ADDENDUM NO. 1

JOHN CAIN SEWER LINE REPLACEMENT PROJECT May 9, 2018

TAHOE CITY PUBLIC UTILITY DISTRICT
JOHN CAIN SEWER LINE REPLACEMENT PROJECT
SEWER MAIN PLAN & PROFILE
STA: 0+00 - 2+50
 TAHOE CITY PLACER COUNTY CALIFORNIA

C1R

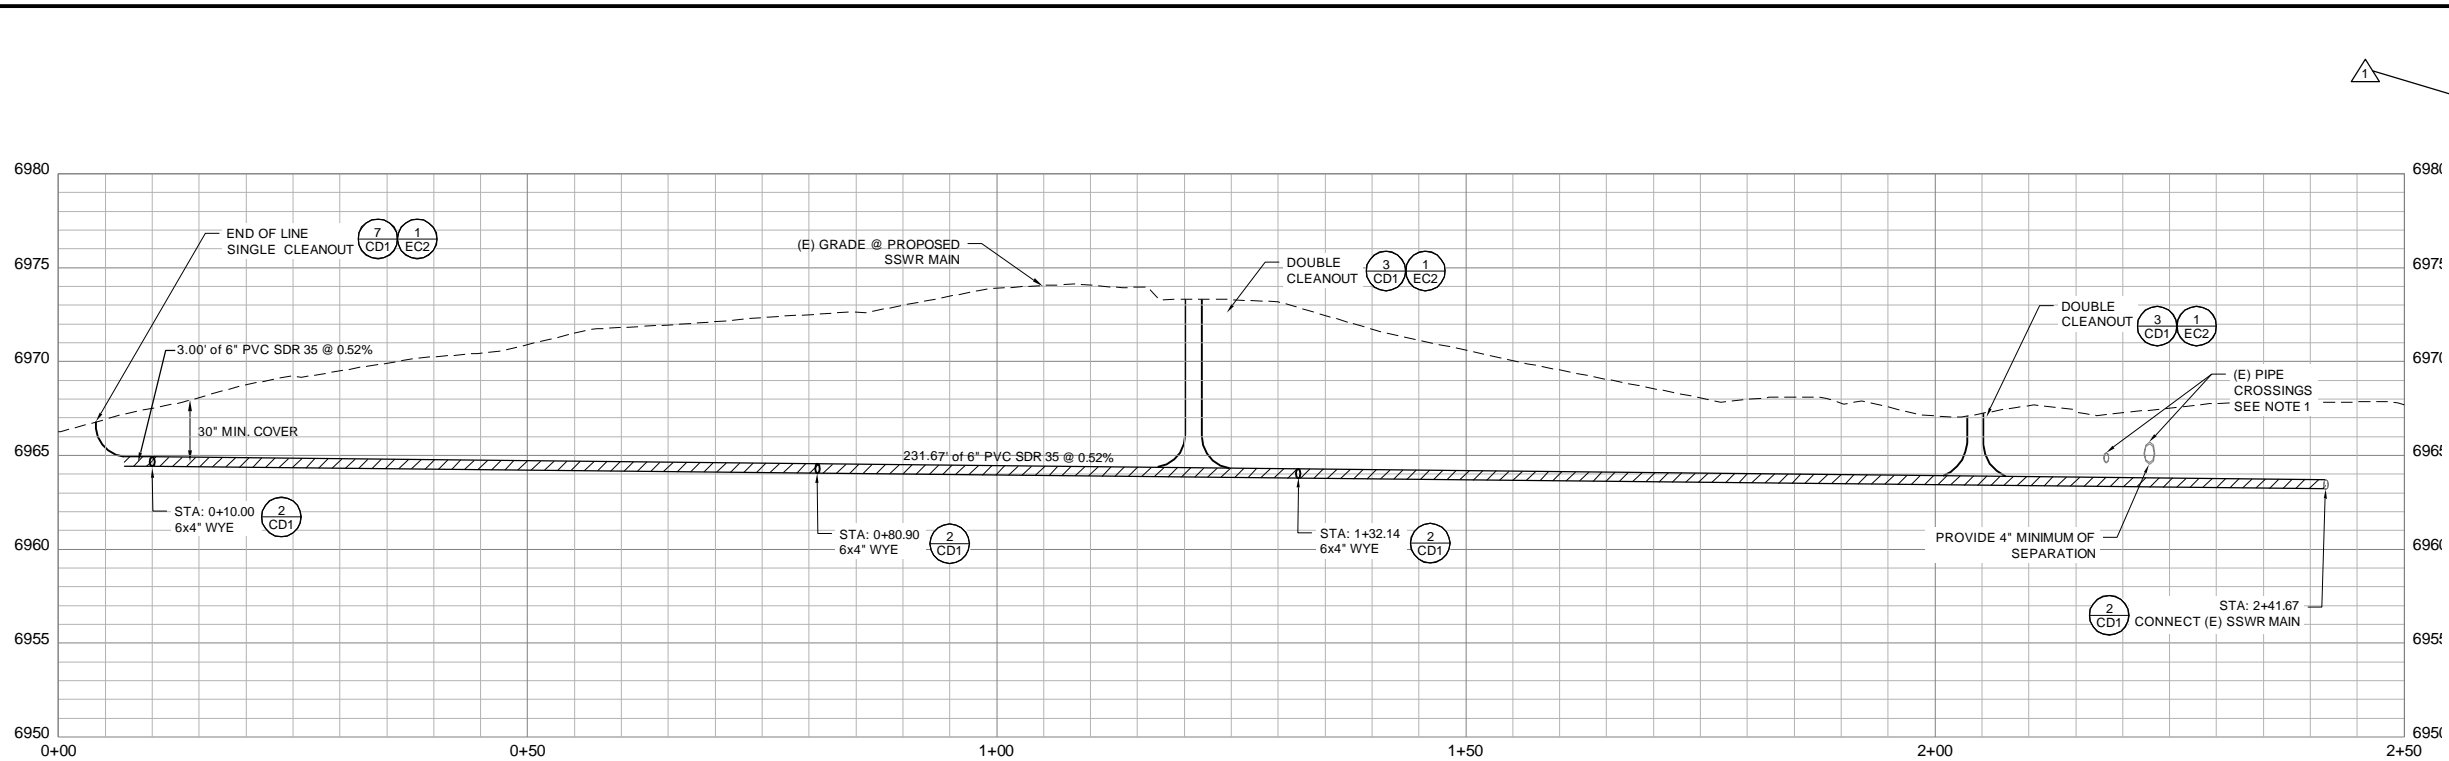
The sewer service for the residential property located at 438 John Cain Road (APN 083-340-014; southeast corner of Silvertip Drive and John Cain Road) is being included in the Project, via this addendum. The work includes abandonment of the sewer service within the public utility easement (PUE) and at the main in Silvertip Drive. The new sewer service connection includes installation of a double cleanout at limit of the PUE and connection to the new 6-inch sewer line at STA 1+32, as show on plan sheet C1R, attached. The following revisions are included:
